Wayzata Planning Commission

Project Name: Zitzloff Redevelopment
Applicant: Lowell Zitzloff
Addresses of Request: 305 and 309 Lake St E
Prepared by: Jeff Thomson, Director of Planning and Building
“60 Day” Deadline: October 26, 2018 (120 day extension)

The Design Review Critique is based on the following plans submitted by the applicant:

ALTERNATE NORTH ELEVATION
WITHOUT ROOFTOP PATIO

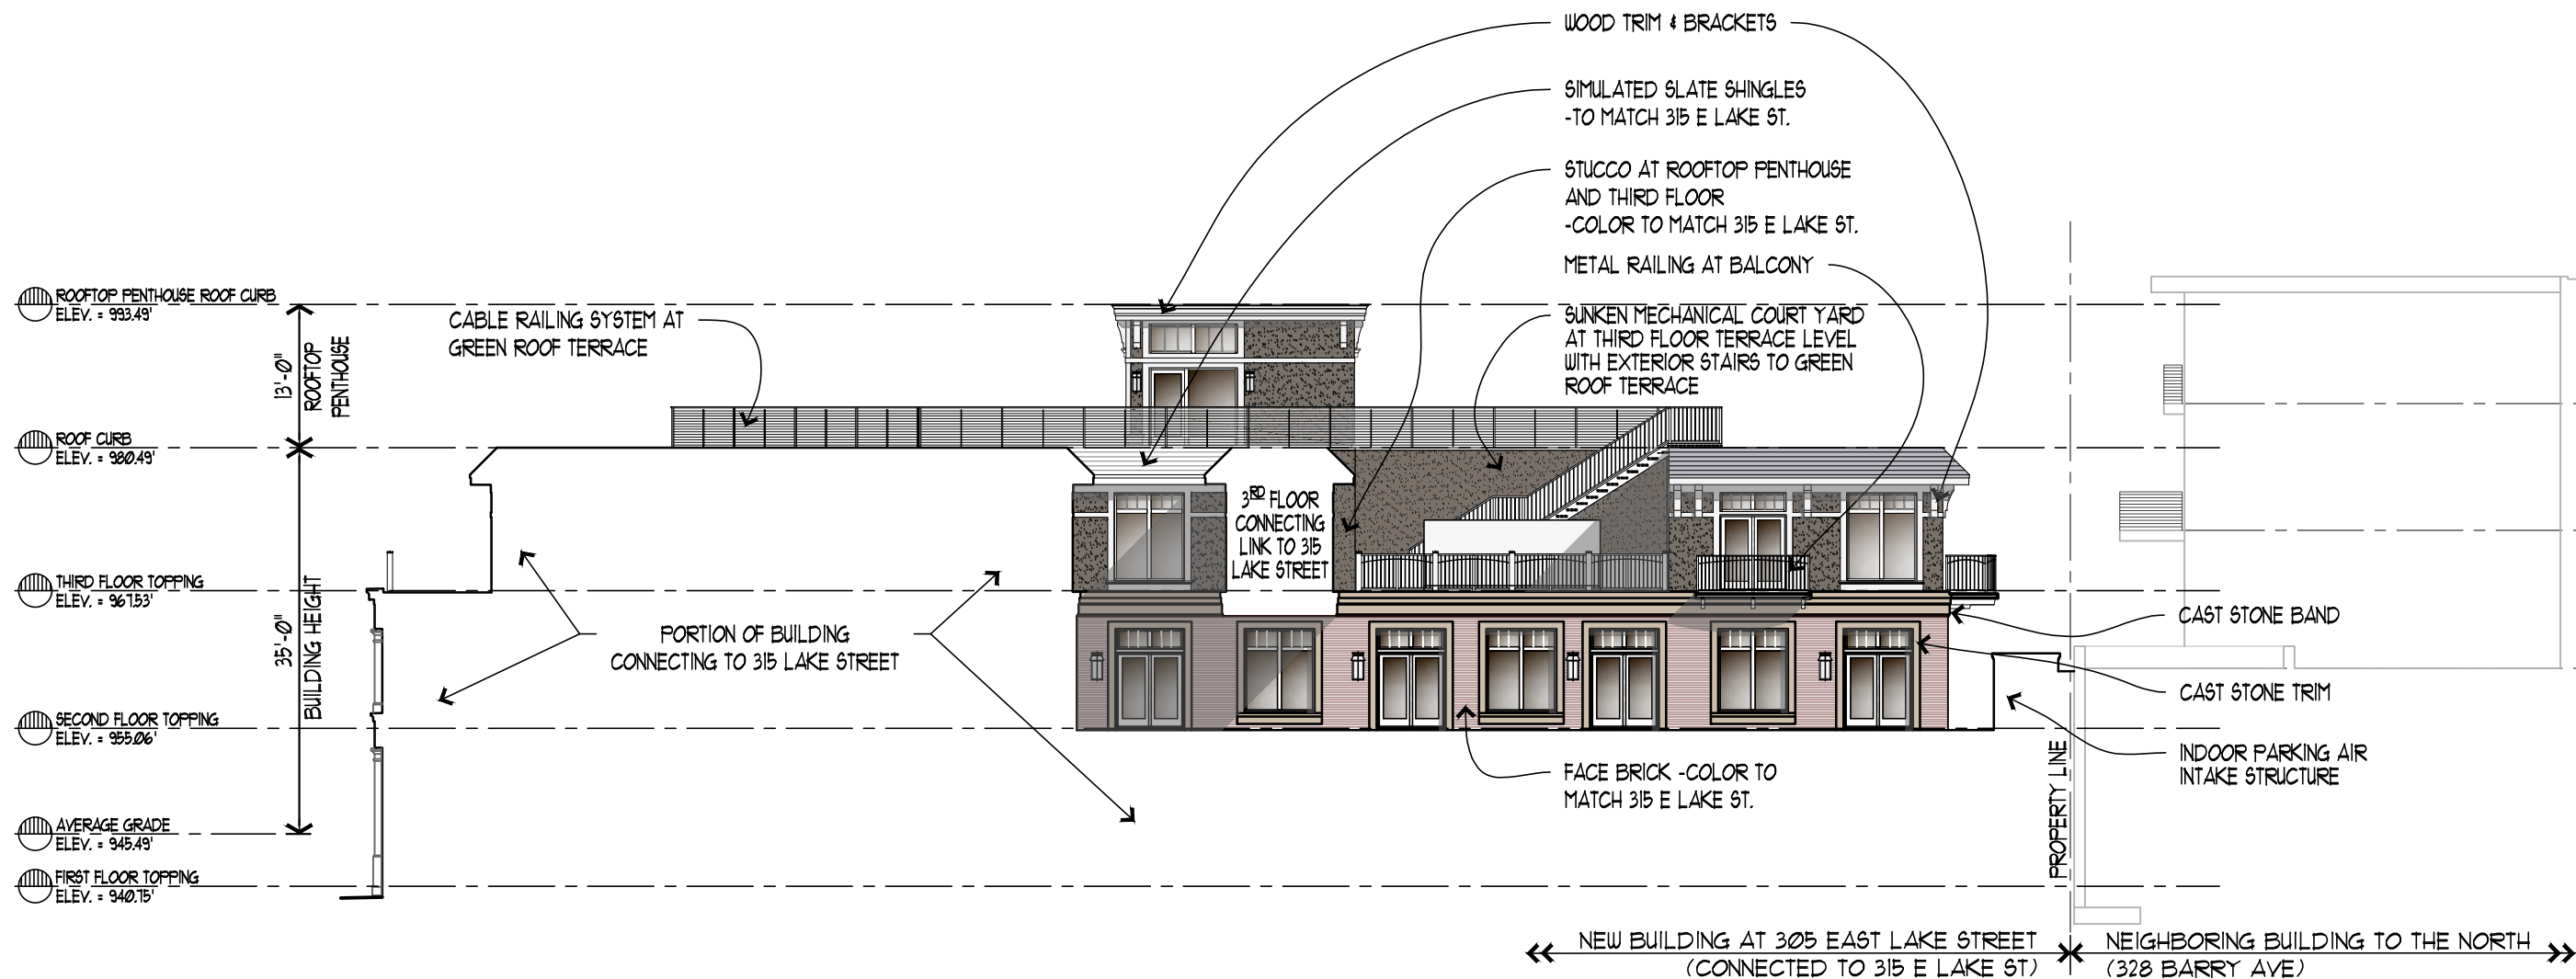
of 48 feet, which exceeds the 40-foot maximum height requirement. The alternative plan meets the 40-foot height requirement to the elevator overrun.
